Zoning Board of Appeals Staff Report

This staff report was prepared for the Zoning Board of Appeals meeting on April 8, 2024.

Applicant(s): Matthew Morton
Property Address: 608, 612, 616, and 620 Commerce Drive
Parcel ID Numbers: 15 246 01 013, 014, 015, and 016
Land Use/Zoning: Low Density Residential / R-60 Single Family
Proposed Dev: Quadplex and Duplex
Variance Request: Front and Side Setback

CONCEPTUAL SITE PLAN
1/32"=1'-0"

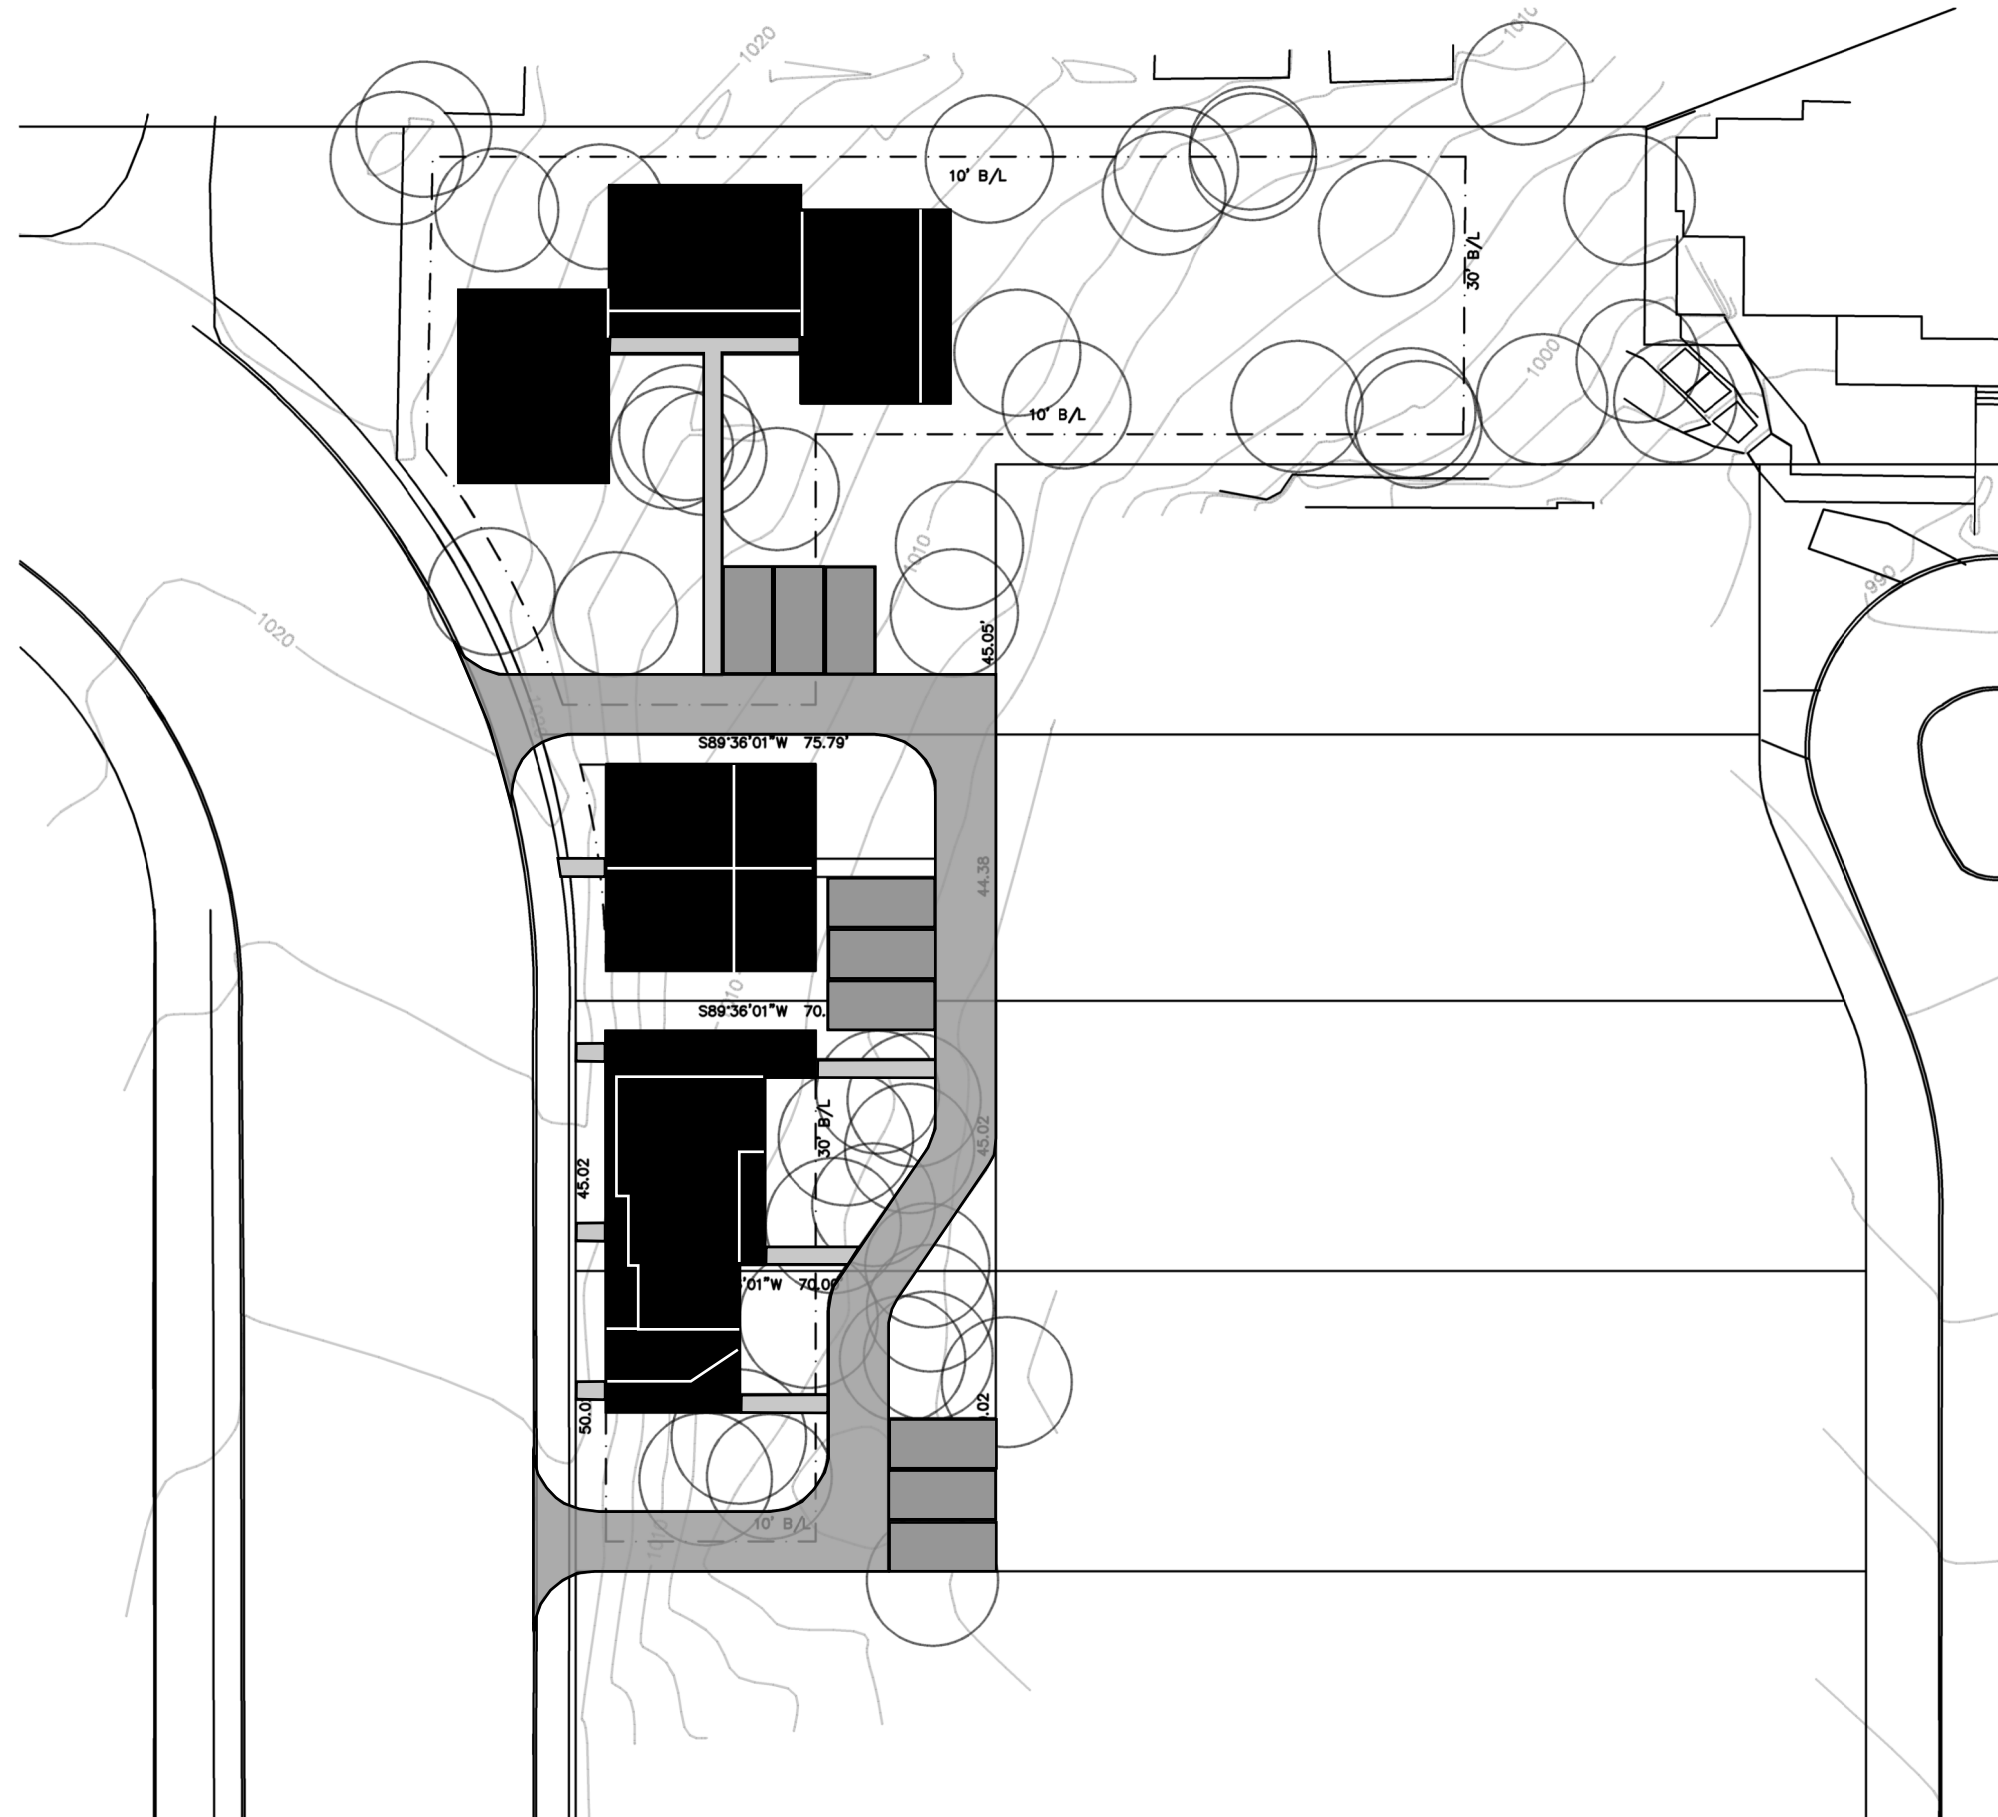
Staff recognizes that the lots are legal non-conforming in depth and size. Nonconforming-standards allow for the reconfiguration of lots only if the minimum lot area requirements are met on the R-60 zoning district. The character of this portion of Commerce Drive does not have large set of active residential uses, with the closest being a large lot single-family detached residence south the of the site at the corner of Commerce Drive and E Ponce de Leon Avenue. The three existing non-conforming lots have a depth of 65-feet within a zoning district that typically requires a minimum depth of 120-feet. Approval of the 5-foot front yard variance request would allow for greater usability for a middle housing development that would act as a transition between the downtown of the city and adjacent single-family detached residences. Due to UDO requirements the three non-conforming lots would be required to recombine to allow for the use of a quadplex or duplex. The recombination of these parcel would provide a greater area to meet the R-60 side setback requirements. Staff recommends approval of the 5-foot front yard variance request and denial of the side setback variance request.
